Product Change Notification

Product change notification number:
PCN_20151203_RM_Display_3000

Title: New enclosure RM Display 30xx

RM Display 3011 und RM Display 3012

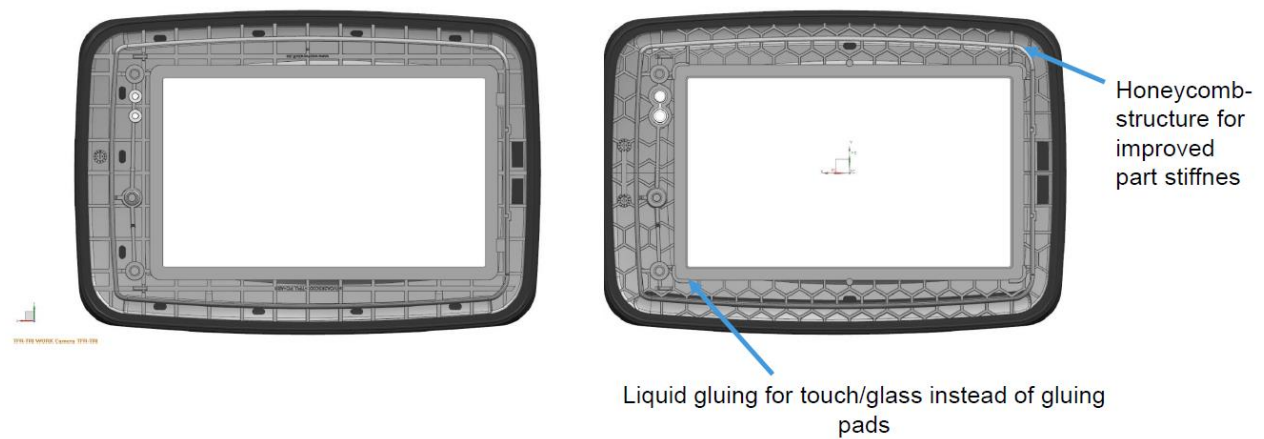
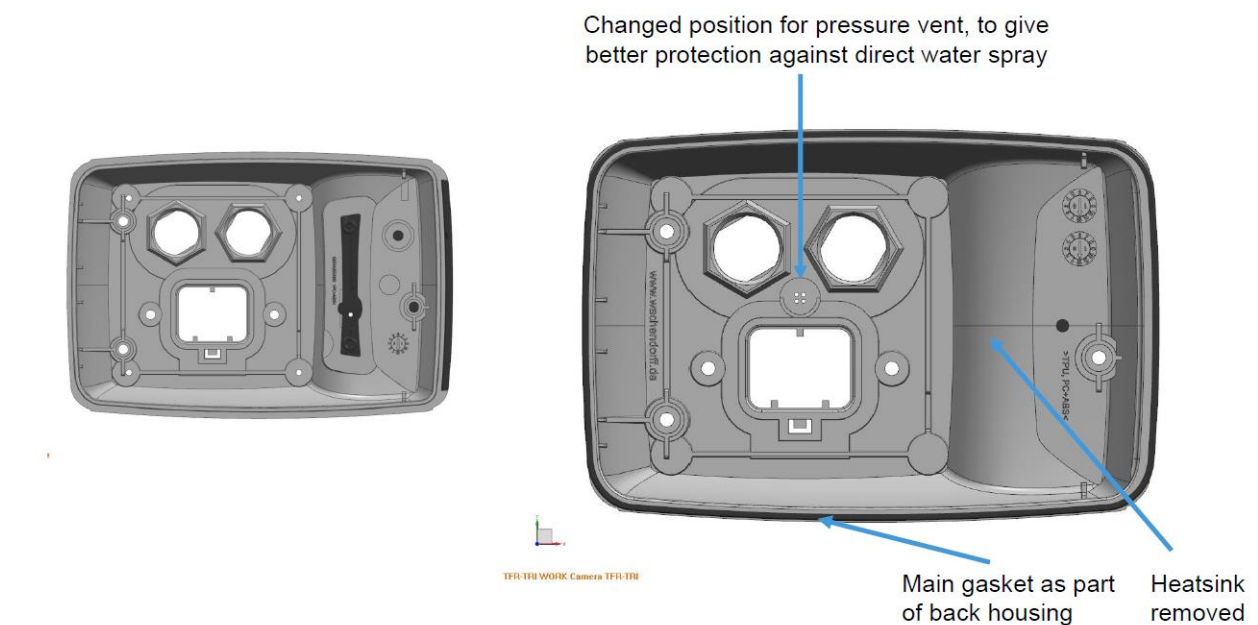
Revision of housing parts.

Several mechanical housing changes with remain consistent housing dimensions

RM Display 3001 und RM Display 3002

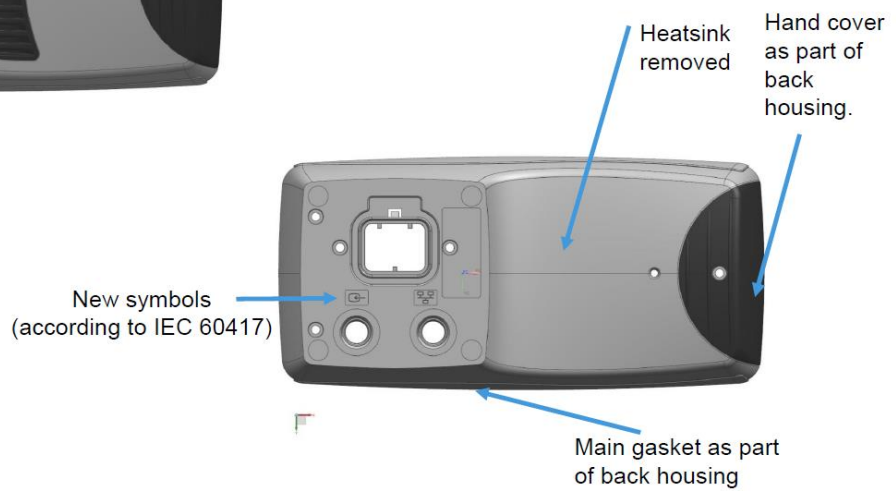
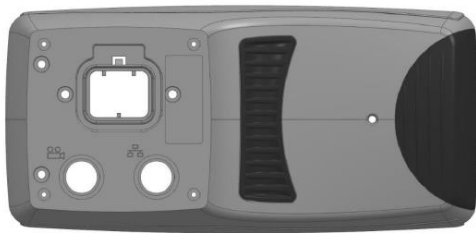
Liquid gluing for Touch/Glass and Keyboard instead of gluing pads

New Injection mold for improvement of optical quality (reduce overmolding and sink marks)
